RE: Sauget Area I TSCA Containment Cell Design Report

**Response to Comments on Sauget Area 1 TSCA Containment Cell Design Report
Time Critical Removal Work Plan, Dead Creek Sediment and Soil in Sauget and Cahokia**

On April 2, 2001, Solutia submitted the Final Sauget Area 1 TSCA Containment Cell Design Report. On April 30, 2001 Solutia received additional comments from IEPA regarding design of the final cover system. The following is Solutia's response to those comments.

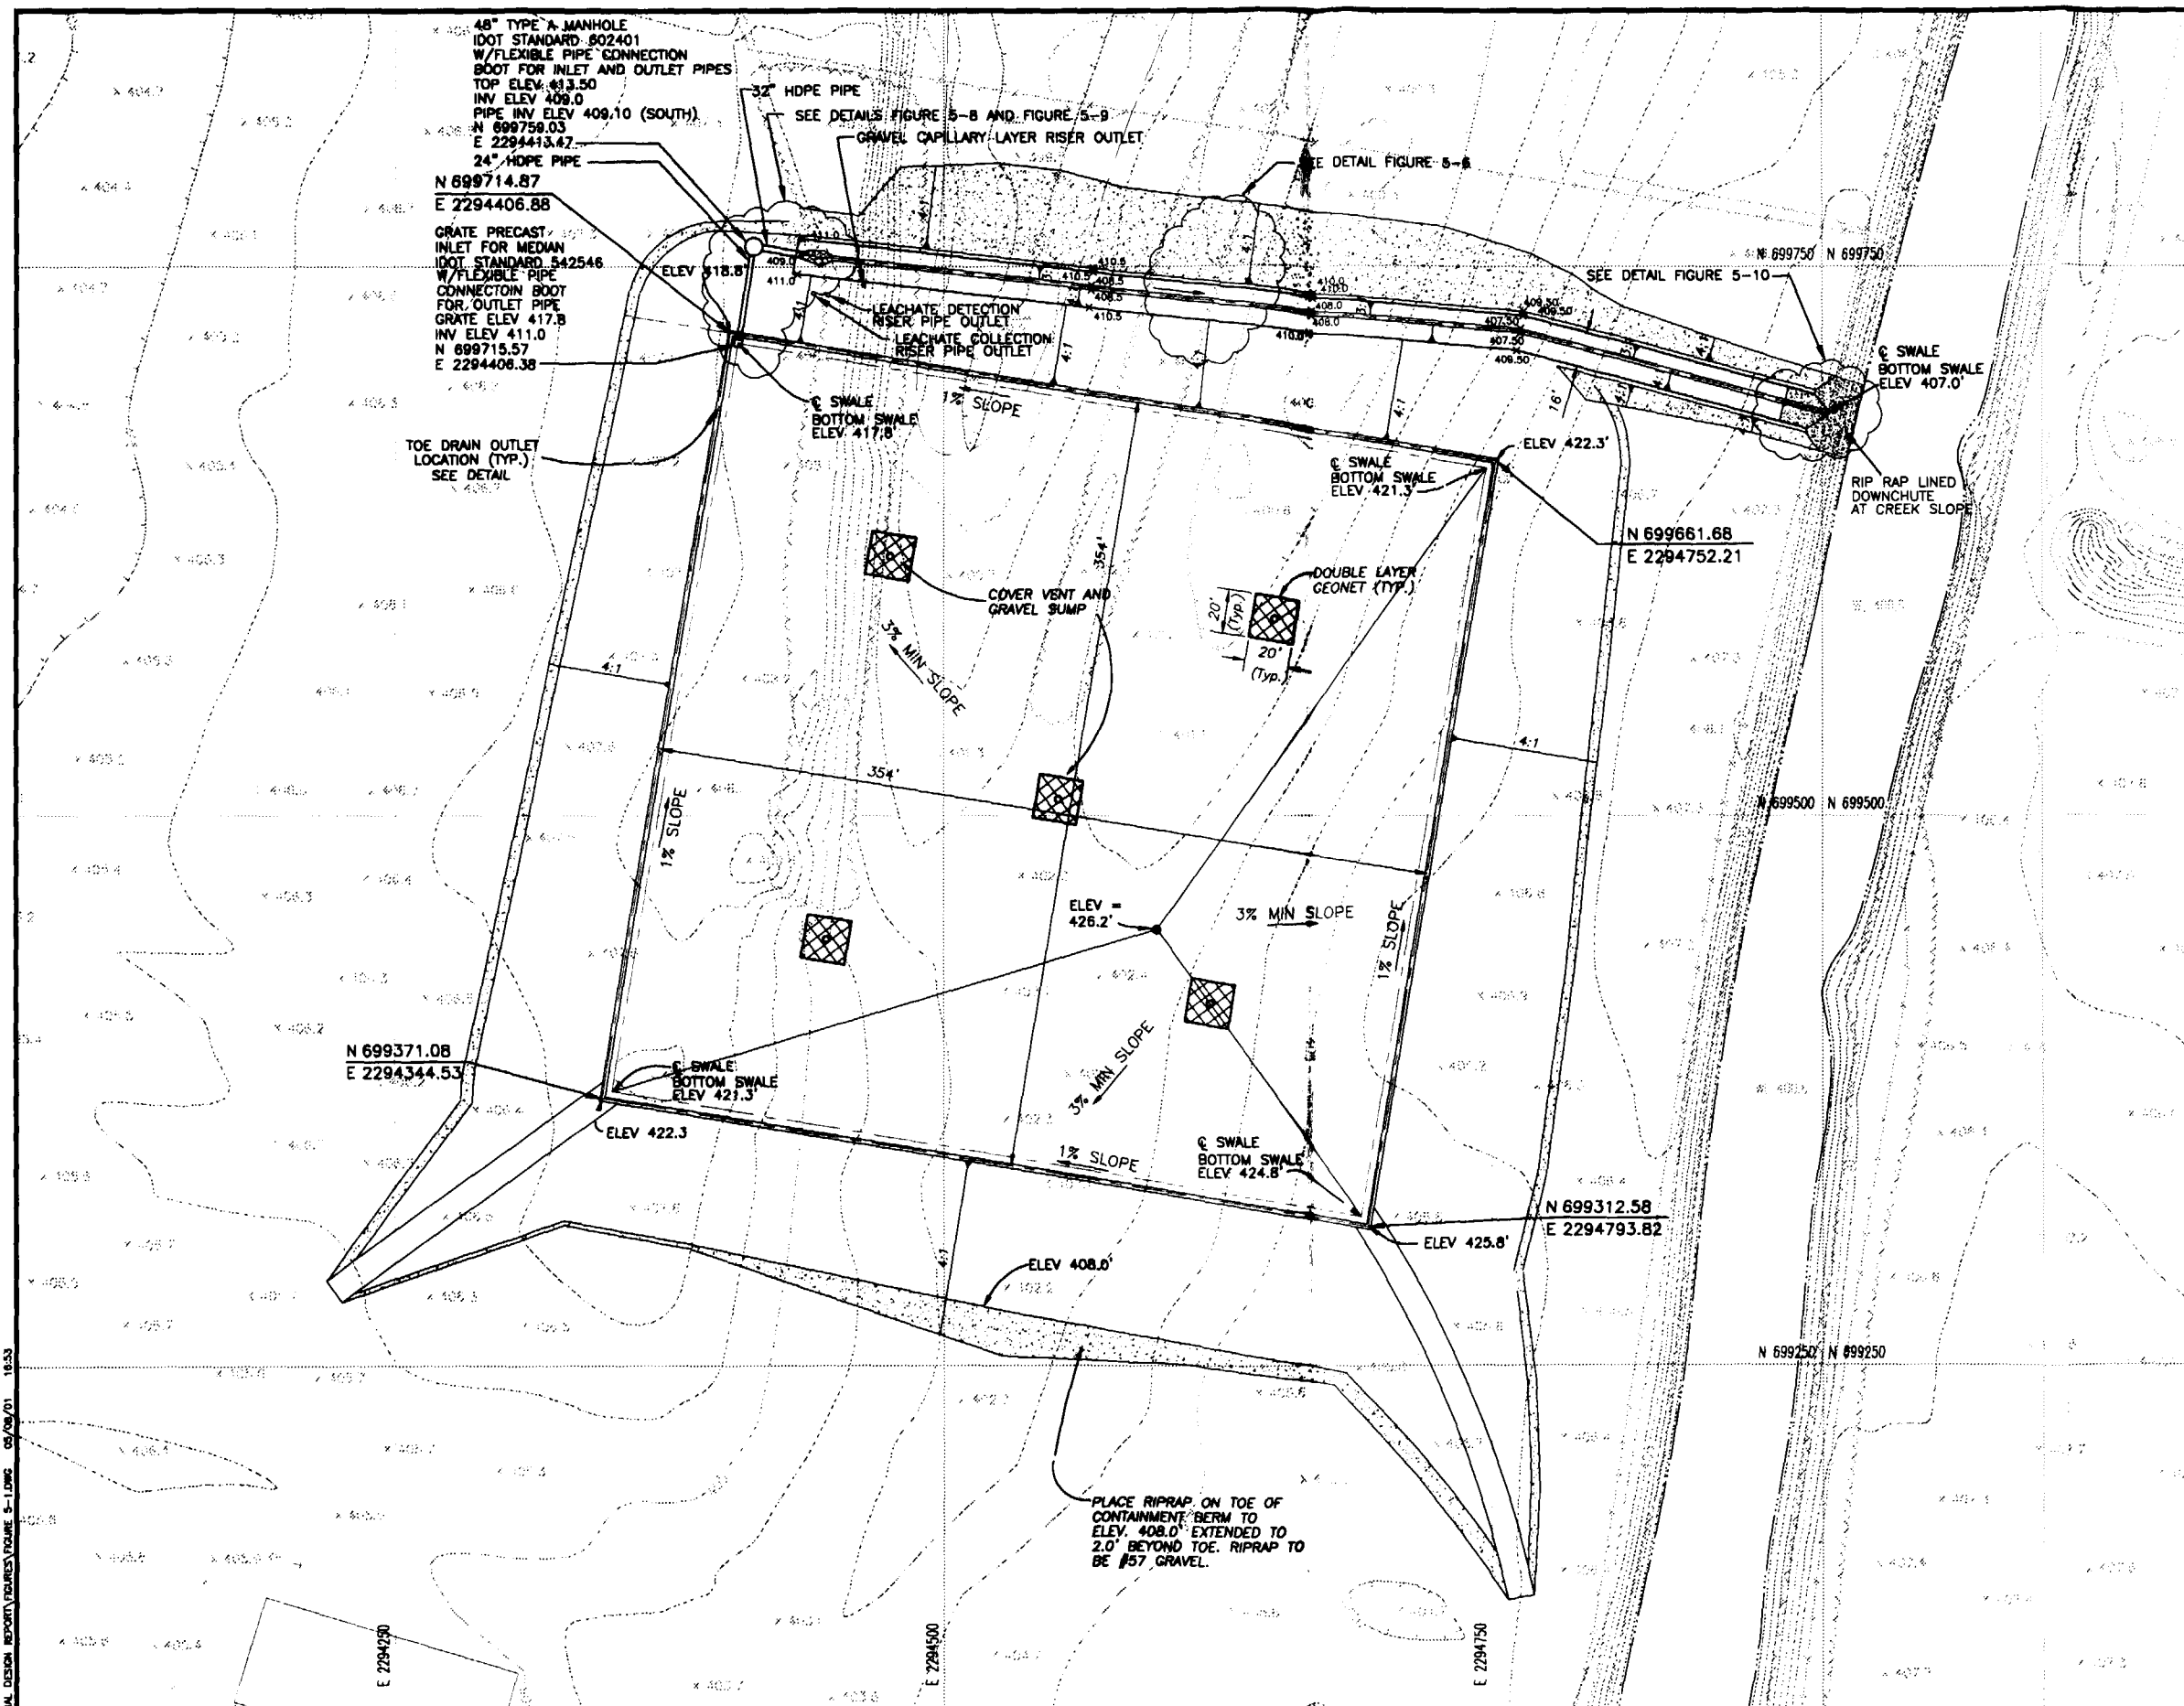
COMMENT	EPA/IEPA DISCUSSION OF RESPONSE TO COMMENTS	SOLUTION RESPONSE
b.	It was my understanding that the downchute along the north berm was to be grass with riprap. Figures 5-1 and 5-6 seem to confirm this conclusion. However, the calculations for a concrete downchute are still in Appendix D. Calculations demonstrating that the grass/riprap design can accommodate the flow from a 25-year, 24-hour storm event, and not be subject to excessive erosion, need to be provided in Appendix D. If a concrete downchute will be used, Figures 5-1 and 5-6 need to be revised to show the concrete downchute.	The down chute included in the draft version of the design report has been replaced with two drop structures and HDPE piping to transport stormwater to a grassed lined outlet channel that discharges to Dead Creek. Please remove the existing Appendix D from your report and replace it with the attached.

COMMENT	EPA/IEPA DISCUSSION OF RESPONSE TO COMMENTS	SOLUTION RESPONSE
118)	acceptable to discharge the run-off from the closed landfill directly to Dead Creek. A run-off control system for the closed landfill will prevent sediments from washing off the landfill and into the restored Dead Creek. Also, if the cover system fails, and the run-off becomes contaminated, the run-off control system will prevent the contaminated run-off, sediments and wastes, from entering and contaminating the restored Dead Creek. The description of the run-off control system needs to include the following:	runoff from the cell. Stormwater runoff will be routed to a drainage swale on the north side of the cell that discharges to Dead Creek. Design drawings for this swale, which is designed to handle a 25-year, 24-hour storm, are included in Attachment 25 of this Response to Comments Document. They will be included as Figures 5-1 and 5-6 of the Design Report.

**DOWNCHUTE
OUTLET DETAIL**

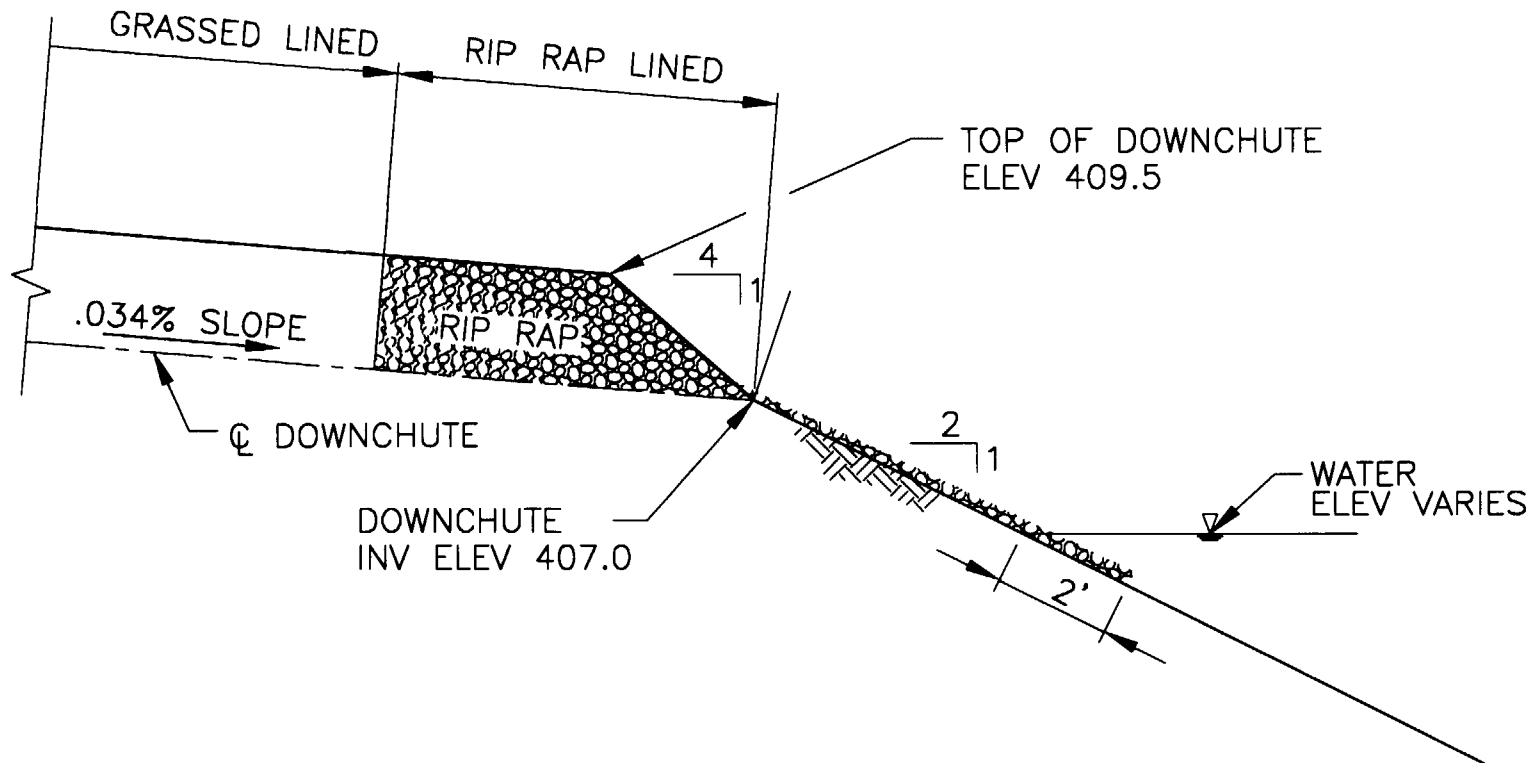
c.	A detail drawing (like Figure 5-8) of the downchute outlet, and its relationship to Dead Creek needs to be provided. Figure 5-8 is titled "Downchute Outlet Detail," but it is actually the downchute inlet.	The figures in Section 5 were revised to provide the requested details. Figure 5-1 was modified to clarify how the details shown in Figures 5-6 through 5-10 relate to the plan view. Existing Figure 5-8 was renumbered to Figure 5-9. Figures 5-8 and 5-10 were added to provide the detail requested. Please remove Figures 5-1 and 5-8 and inset the attached Figures 5-1, 5-8, 5-9, 5-10. In addition Section 5 was revised to identify the new figures and to clarify the design of the cover system. Please remove the Section 5 text and replace it with the attached.

a.	<u>Design and Performance</u> Describe the run-off collection and control system design. Provide calculations demonstrating that the system has sufficient capacity to collect and hold the total run-off volume. Provide a plan view showing the locations of the run-off control system components, along with sufficient drawing details and cross sections. Indicate the fate of the collected run-off.	Section 5.4 describes the cover design and Section 5.5 describes the Run-Off Control Systems. The calculations demonstrating the performance of the final cover system are described in Section 5.5 and included in Appendix D. Figure 5-1 presents the requested plan view of the cell. Details of the stormwater management system are presented in Figures 5-5, 5-6, 5-8, 5-9, and 5-10. The fate of the collected run-off is described in Section 5.
